RE: Petition No. 1230 – Stony Hill Substation Project
Modified Substation Drawing and Aerial Map

**STONY HILL SUBSTATION
 SYNCHRONOUS CONDENSER**

EVERSOURCE ENERGY									
TITLE STONY HILL YARD ARRANGEMENT PLAN & SECTIONS CONNECTICUT SITING COUNCIL BROOKFIELD, CT									
BY	MC	DWG	REM	APP	PSM	DATE	DATE	DATE	DATE
2	2/03	ADD 115KV CAPACITOR W.O. #40091901	MC	REM	REM	6/88	7/88	7/88	7/88
1	12/90	ISSUED FOR CSC APPROVAL 1990 ADDITION	MC	REM	REM				
NO.		DATE	BY	CHK	APP	APP	R.E. DWG	DWG NO.	
								11804-92001

Aerial Map

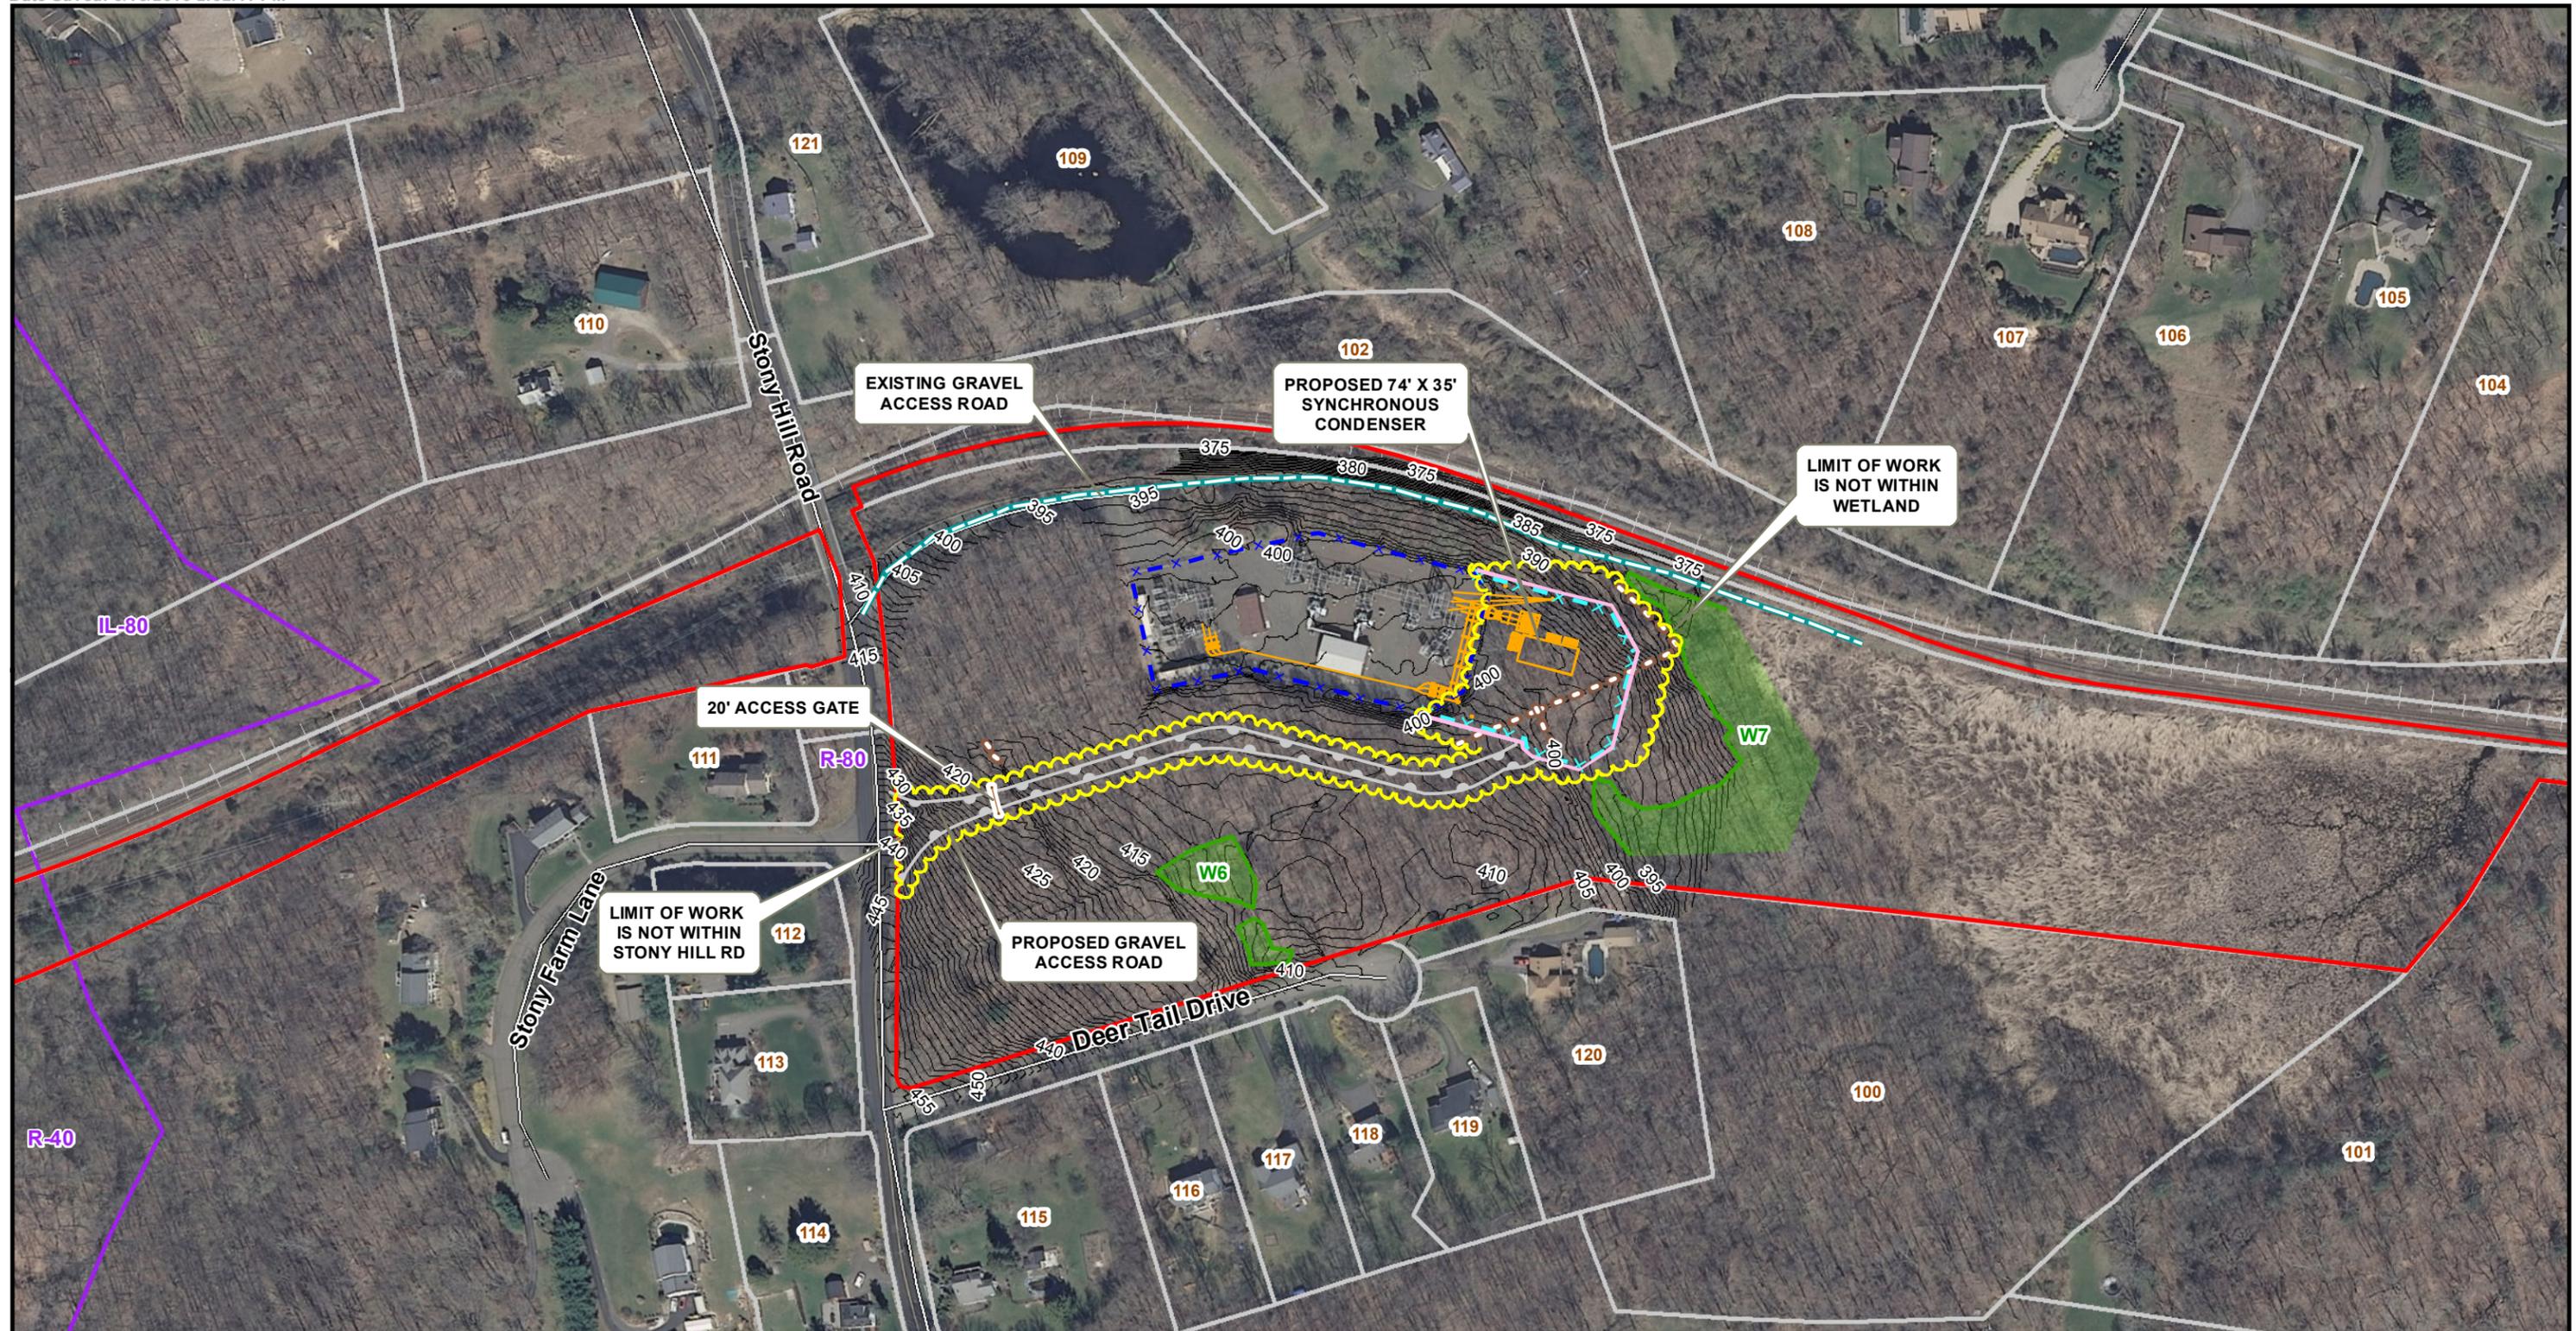
Eversource is providing the attached updated substation drawing (Attachment A) and aerial map (Attachment B) for the Stony Hill Substation. The Petition stated a distance of 30 feet from the southwest corner of the proposed expanded fence line to wetland W7, but this was an error and the distance was actually 7 feet. However, in response to this discovery, Eversource has modified the proposed fence line to increase the distance between the substation and the wetland. With the modified design, the distance to the wetland is now 21 feet.
